Staff Item #1—Anne Fothergill  
September 9, 2009  
33 Quincy Street, Chevy Chase  
**Non-Contributing Resource**

**From:** Wallace Devine [wdevine@ahmannarchitects.com]  
**Sent:** Monday, August 24, 2009 2:33 PM  
**To:** Fothergill, Anne  
**Cc:** Thomas Williams; francesmwilliams83@hotmail.com  
**Subject:** HAWP #493435, Approved September 10, 2008

SUBJECT: Historic Area Work Permit #493435, Rear addition, window replacement, and alterations to front porch.

<b>Address:</b>	33 Quincy Street, Chevy Chase	<b>Meeting Date:</b>	9.10.08
<b>Resource:</b>	Noncontributing Resource Chevy Chase Village Historic District	<b>Report Date:</b>	9.03.08
<b>Applicant:</b>	Thomas Williams	<b>Public Notice:</b>	08.27.08
<b>Review:</b>	HAWP	<b>Tax Credit:</b>	None
<b>Case Number:</b>	35/13-08T	<b>Staff:</b>	Rachel Kennedy
<b>PROPOSAL:</b>	Rear addition, window replacement, and alterations to front porch

FRONT  
ELEVATION

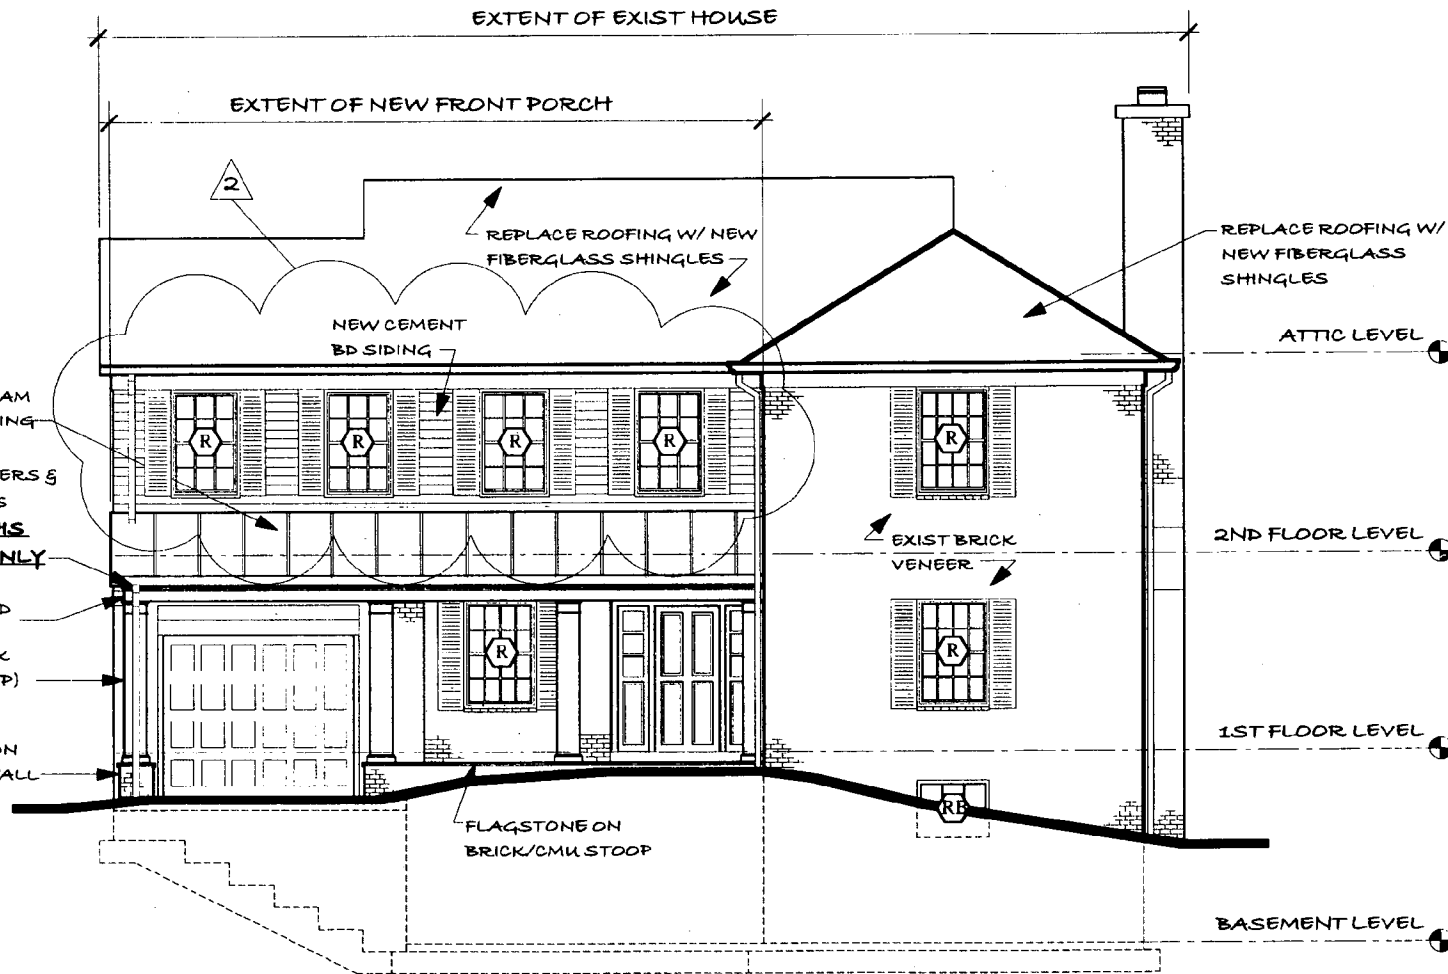
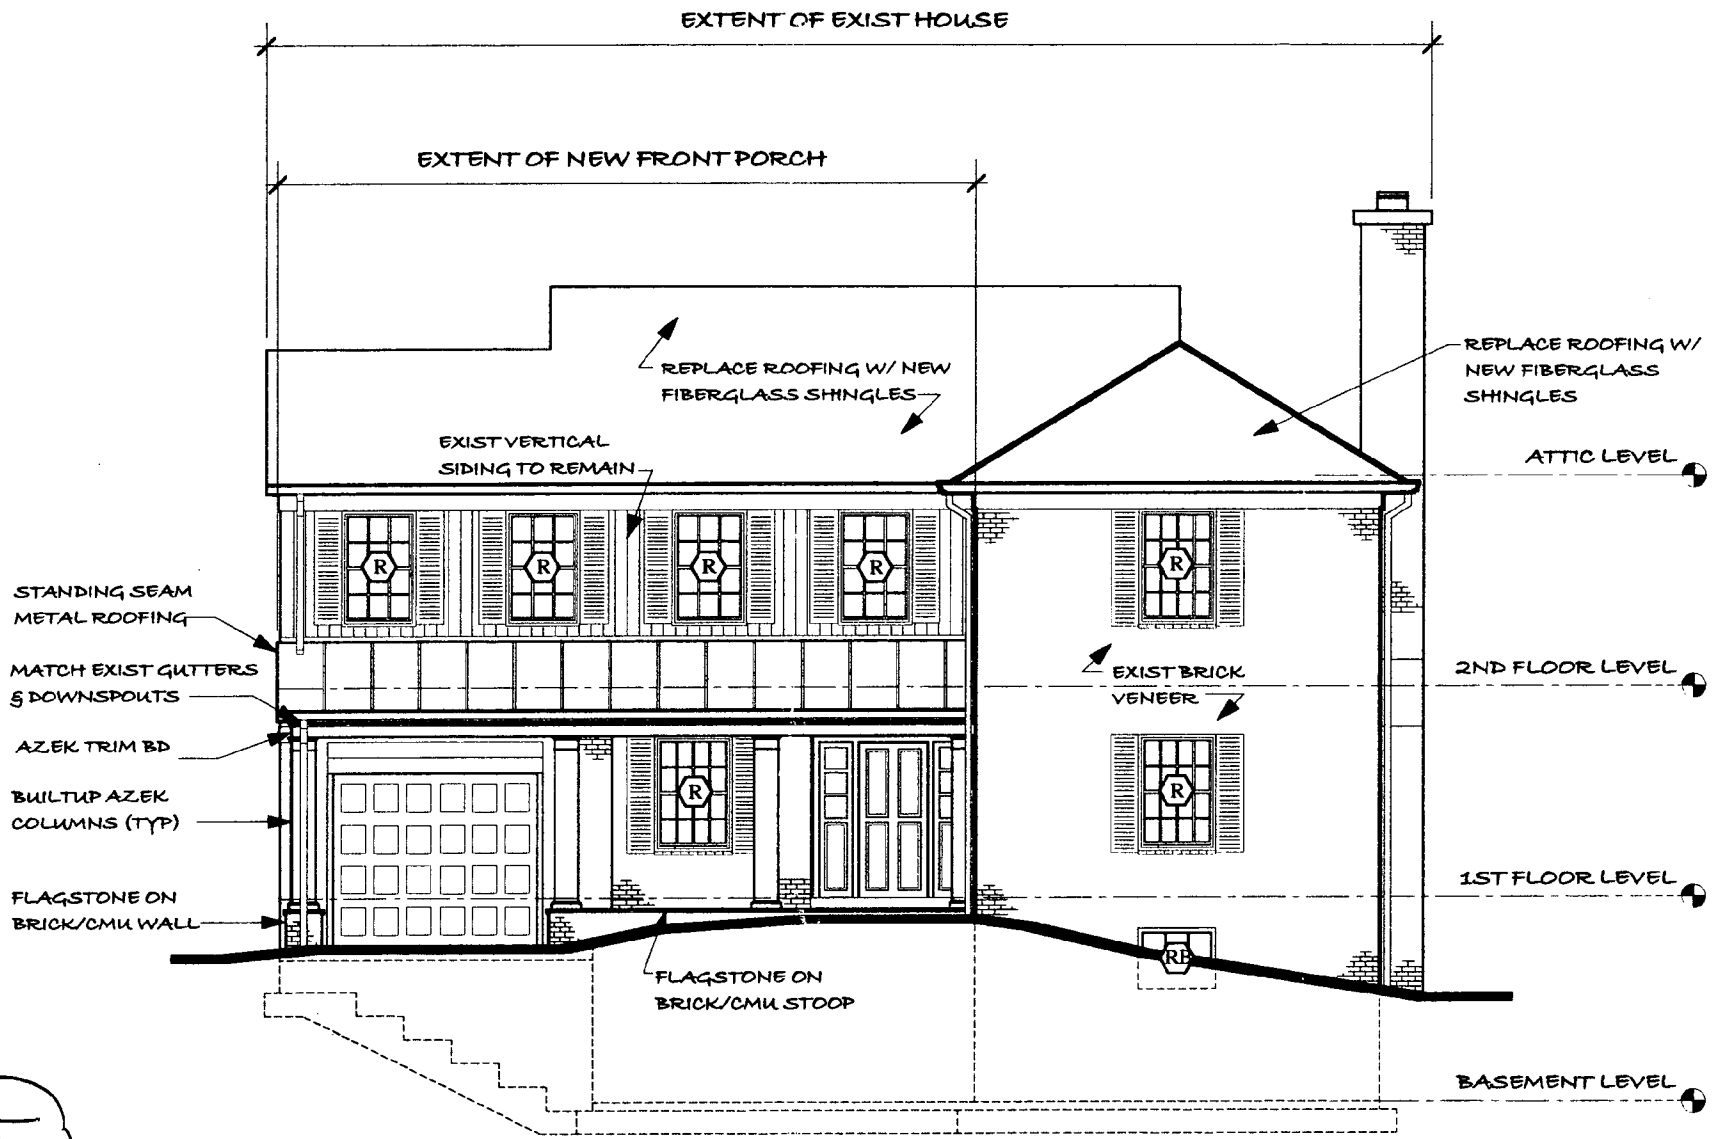
In September 2008 the HPC approved alterations to the front porch of this house as well as a rear addition. The applicants now propose a minor change to the approved plans—they would like to replace the existing vertical siding on the second story of the front of the house to horizontal cement board siding. Approved and proposed plans attached. Staff is requesting that the HPC allow this change to be approved at the staff level.

REV 2: REVISION 2 CONSISTS OF CHANGES TO THE SIDING ON THE FRONT OF THE HOUSE. THE ORIGINAL PLAN SPECIFIED THAT THE EXIST VERT SIDING AT FRONT OF HOUSE WOULD REMAIN. THAT SIDING NOW SHALL BE HORIZONTAL CEMENT BOARD SIDING AS ON OTHER PARTS OF THE HOUSE. NO OTHER CHANGES TO PROJECT.

TYPICAL  
PILASTER/COLUMN  
DETAIL

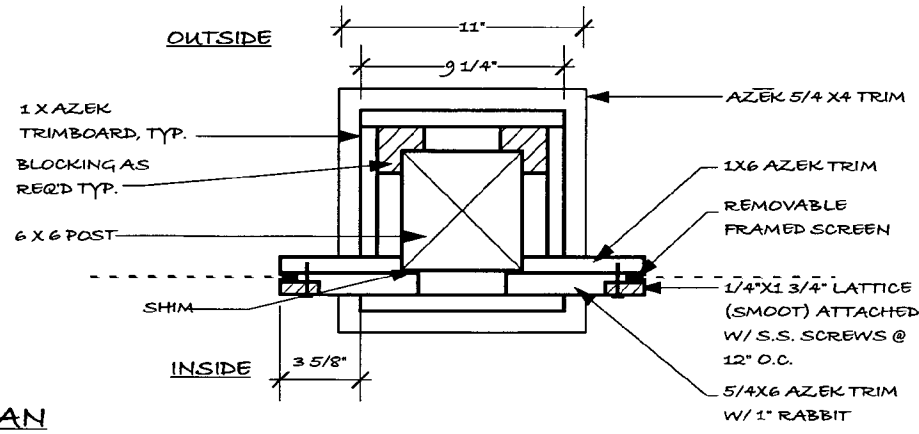
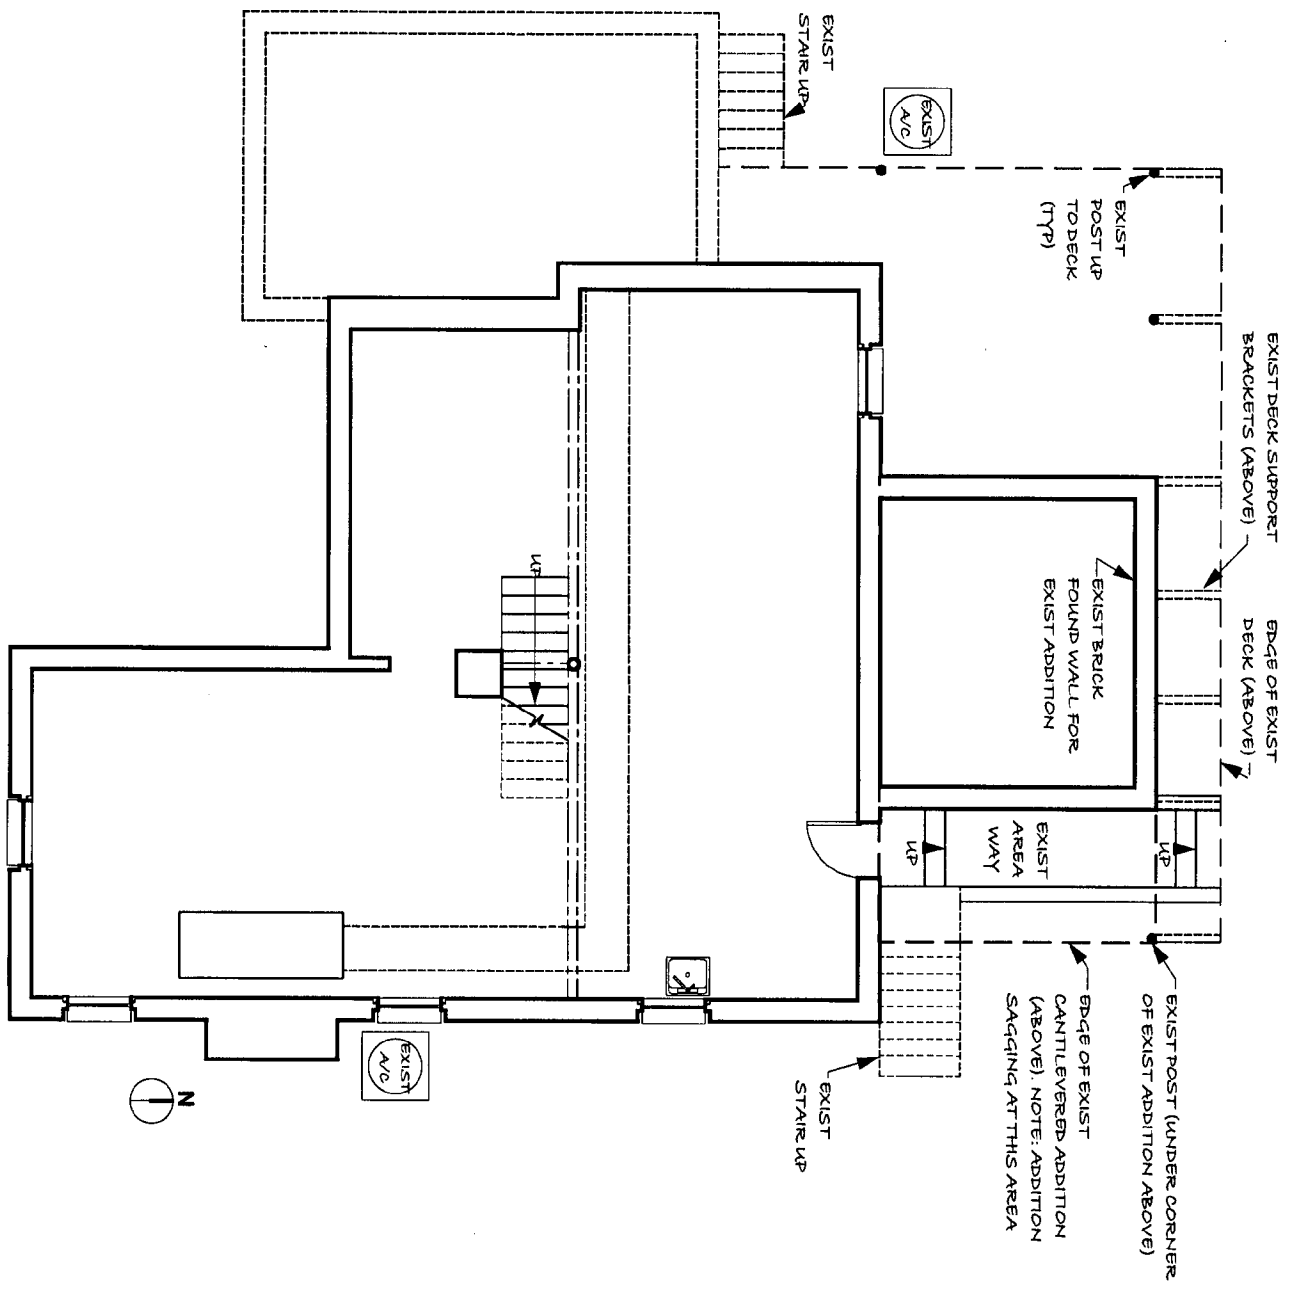
Yes to all. The columns will be structural posts wrapped with Azek Board (the same as was done on the Digiuseppe project - see the photo to question #1 above). I have also added a drawing (A-8 attached) to the submitted set which shows the details of the built up column.

**EXISTING  
 BASEMENT PLAN**

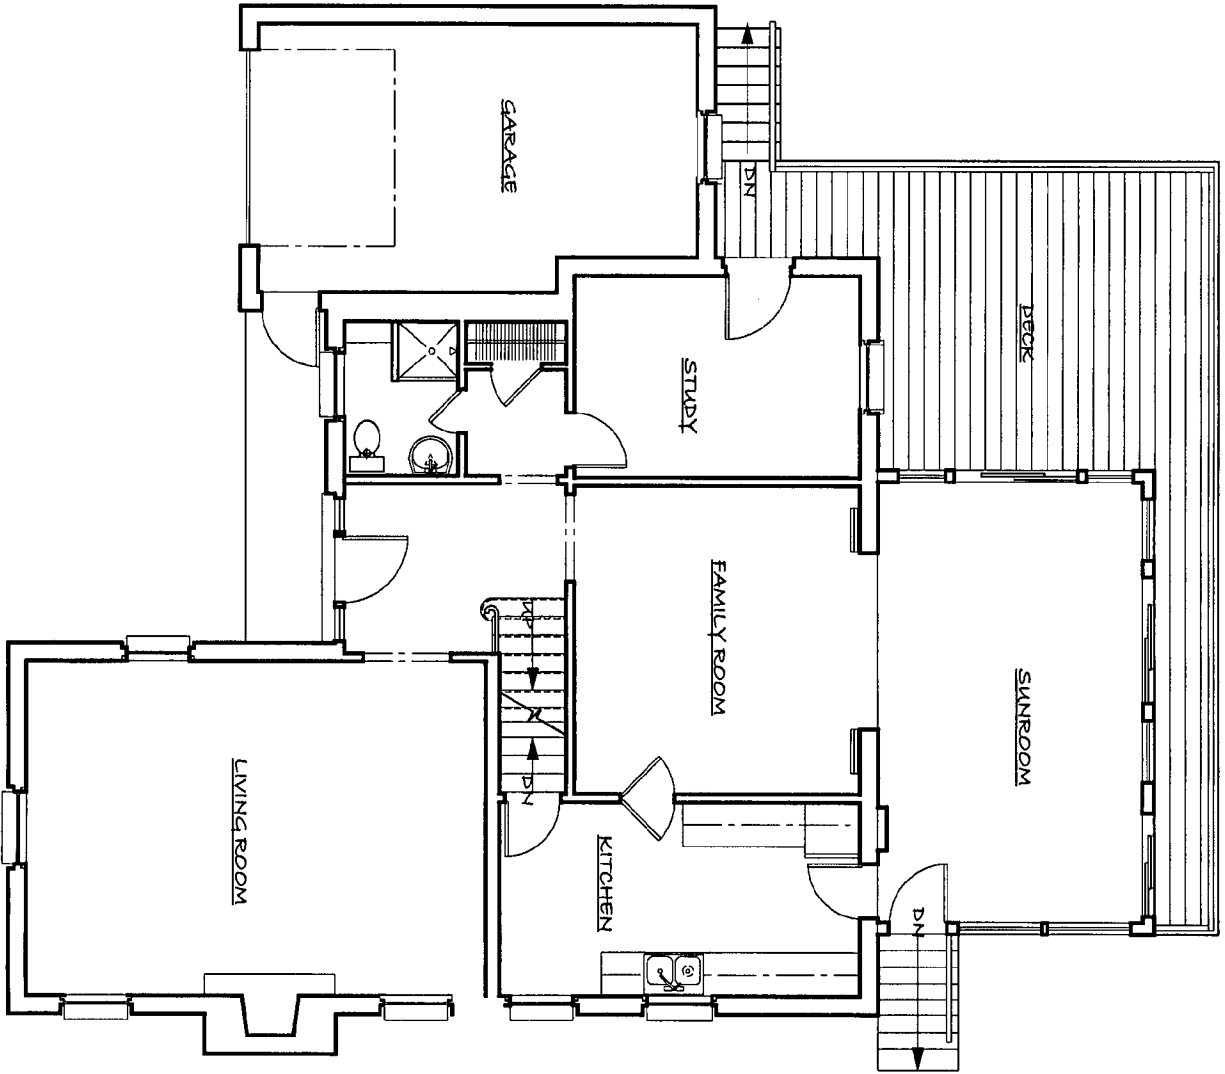
5) You state in the application that you are to tear down the one-story rear addition and rebuild on the same foundation. Just to be clear, there is no foundation per se, as the old addition is cantilevered over a central brick support pier. Correct? You will be extending the brick foundation wall from the main house, right? Is this to be built on the same brick pier footprint or the footprint of the larger old addition?

Im sorry the actually conditions were not clear in the photographs or proposed plan so, I am attaching the measured plans (MD5, MD6, and MD7) to more clearly show the new and old in plans and the cantilever condition. The shaded new foundation wall labeled "10" brick wall to replace exist" is actually not replacing an existing wall. It is a new wall.

There is no existing wall there. There is an existing area way and an existing post which holds up the cantilevered portion of the existing addition at the corner (see MD5 and photos). Again, that cantilevered portion is sagging, so we are removing the post and putting in the new brick/CMU wall for structural support. It will align exactly where the existing addition is held up by the post so there will be no change to the footprint.
